OHIO TURNPIKE COMMISSION

ADDENDUM NO. 1

CONTRACT NO. 59-13-01
REPAIRS AND RESURFACING
EASTBOUND AND WESTBOUND ROADWAYS
MILEPOST 27.5 TO MILEPOST 38.9
FULTON COUNTY, OHIO

Plan Sheet 6 of 14

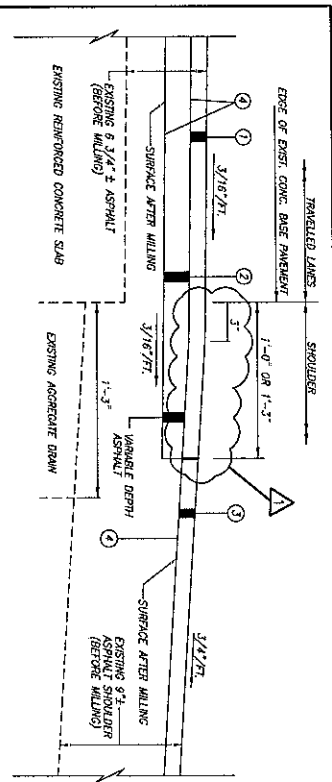
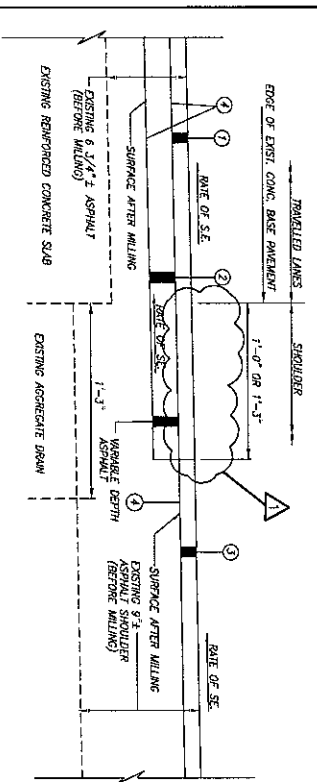
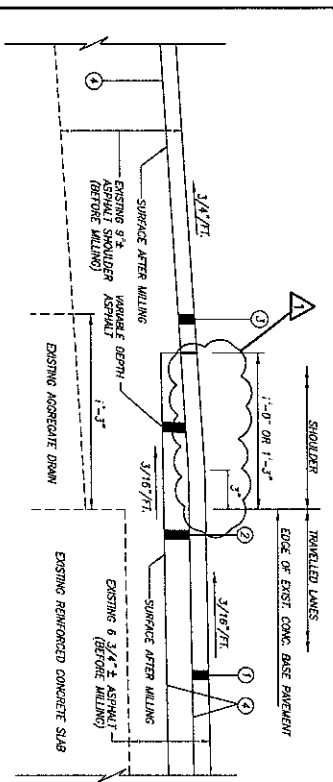
Q#3 Please verify the bid quantity for ref. 21 "SP404 Surface Course P64-22". It appears based on plan calculations that the bid quantity is 500 cy +/- below plan quantity.

The paving joints on Details A, B and C were revised outwards towards the shoulder to clarify the paving limits.

A#3 Plan Sheet 6 of 14 has been revised via this Addendum No. 1 to provide additional clarity to the determination of the estimated quantity for Ref. No. 21. The quantity listed is approximate and intended as the estimated quantity to be provided without the need for a Change Order.
